UNITED STATES PATENT AND TRADEMARK OFFICE

APPLICATION NO.	FILING DATE	FIRST NAMED INVENTOR	ATTORNEY DOCKET NO.	CONFIRMATION NO.
10/542,961	07/21/2005	Christopher Neil Wood	038665.56621US	2045
23911 7590 05/03/2007 CROWELL & MORING LLP INTELLECTUAL PROPERTY GROUP P.O. BOX 14300 WASHINGTON, DC 20044-4300			EXAMINER AMIRI, NAHID	
			ART UNIT 3679	PAPER NUMBER
			MAIL DATE 05/03/2007	DELIVERY MODE PAPER

Office Action Summary	Application No. 10/542,961	Applicant(s) WOOD ET AL.	
	Examiner Nahid Amiri	Art Unit 3679

DETAILED ACTION

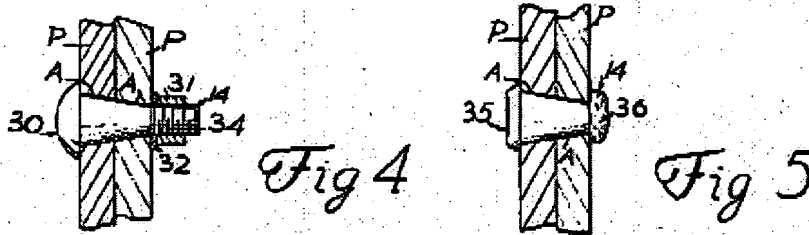
Claims 1-3, 6, and 10 are rejected under 35 U.S.C. 102(b) as being anticipated by US Patent No. 3,369,440 King, Jr.

With respect to claim 1, King, Jr. discloses an assembly (Figs. 4-5) comprising a fastener (30), a panel (P) and a supporting structure (P) to which the panel (P) is detachably fastened by the fastener (30), the panel (P) and supporting structure (P) being formed with tapered holes (A) which receive the fastener (30), the taper of one hole (A) being a continuation of the taper (A) of the other, and the fastener (30) urging a tapered surface into the tapered holes (A) in a non-jamming manner thereby locating the panel (P) with respect to the supporting structure (P).

With respect to claims 2, 3, and 6, respectively, King, Jr. discloses (Figs. 4-5) that the fastener (30) is positioned in the holes so as not to project beyond an external surface of the panel (P); wherein the tapered surface is formed on the fastener (30) itself; and wherein the angle of taper of the holes (A) and the angle of taper of the said tapered surface are the same.

With respect to claim 10, King, Jr. discloses a fastener (Figs. 4-5) for fastening a detachable panel (P) to a supporting structure (P), the panel (P) and supporting structure (P) being formed with tapered holes (A) which receive the fastener (30), the taper of one hole (A) being a continuation of the taper (A) in the other, the fastener (30) comprising a body having a tapered outer surface which is arranged to locate in the tapered holes (A) in a non-jamming manner and thereby position the panel (P) with respect to the supporting structure (P).

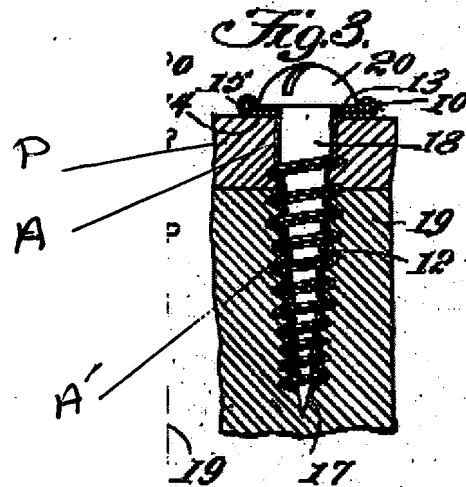
Claims 1-4, 6, 10, and 12 are rejected under 35 U.S.C. 102(b) as being anticipated by US Patent No. 2,666,354 Dim et al.

With respect to claim 1, Dim et al. disclose an assembly (Fig. 3) comprising a fastener (18), a panel (P) and a supporting structure (19) to which the panel (P) is detachably fastened by the fastener (19), the panel (P) and supporting structure (19) being formed with tapered holes (A, A') which receive the fastener (18), the taper of one hole (A) being a continuation of the taper (A') of the other, and the fastener (18) urging a tapered surface into the tapered holes (A, A') in a non-jamming manner thereby locating the panel (P) with respect to the supporting structure (19).

With respect to claims 2, 3, 4, and 6, respectively, Dim et al. disclose (Fig. 3) that the tapered surface is formed on the fastener (18) itself; wherein the tapered surface is formed on an element (12) located in the tapered holes (A, A'), and the fastener (18) passing through the element (12) to hold the element (12) in place; wherein the angle of taper of the holes (A, A') and the angle of taper of the said tapered surface are the same.

With respect to claim 10, Dim et al. disclose a fastener (Fig. 3) for fastening a detachable panel (P) to a supporting structure (19), the panel (P) and supporting structure (19) being formed with tapered holes (A, A') which receive the fastener (18), the taper of one hole (A) being a continuation of the taper (A') in the other, the fastener (18) comprising a body having a tapered outer surface which is arranged to locate in the tapered holes (A, A') in a non-jamming manner and thereby position the panel (P) with respect to the supporting structure (19).

With respect to claim 12, Dim et al. disclose a fastener means (Fig. 3) for fastening a detachable panel (P) to a supporting structure (19), the fastening means comprising a tapered element (12) and a fastener (18), the panel (P) and supporting structure (19) being formed with tapered holes (A, A') which receive the tapered element (12) and the fastener (18), the taper of one hole (A) being a continuation of the taper in the other (A'), the tapered element (12) comprising a body having a tapered outer surface and having bore through which the fastener (18) can be passed to secure the tapered element (12) in the tapered holes (A, A') and thereby position the panel (P) with respect to the supporting structure (19).

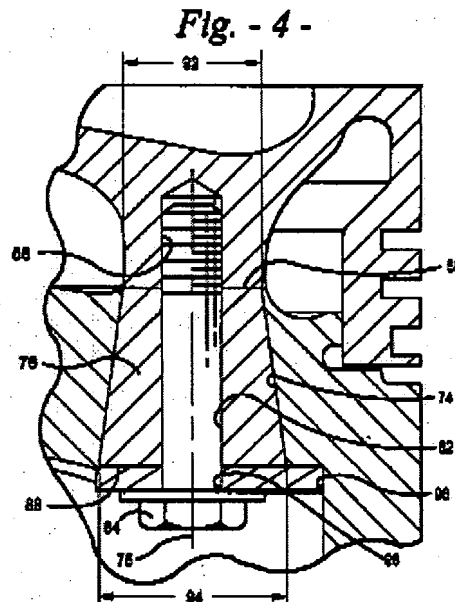
Claims 4 and 5 are rejected under 35 U.S.C. 103(a) as being unpatentable over King Jr. as applied to claims 1-3, 6, and 10 above, and further in view of US Patent No. 6,164,261 Kruse.

With respect to claims 4 and 5, King, Jr. discloses the claimed invention except that the tapered surface is formed on an element located in the tapered holes, and the fastener passing through the element to hold the element in place; and wherein the element is of frusto-conical form. Kruse teaches an assembly (Fig. 4) having a tapered surface is formed on an element (76) located in the tapered hole and a fastener (84) passing through the element to hold the element in place and the element (76) is of frusto-conical form. It would have been obvious to one of ordinary skill in the art at the time of invention was made to form the tapered surface of King, Jr. on an element located in the tapered hole as taught by Kruse in order to provide adequate stiffness for joining the two members together.
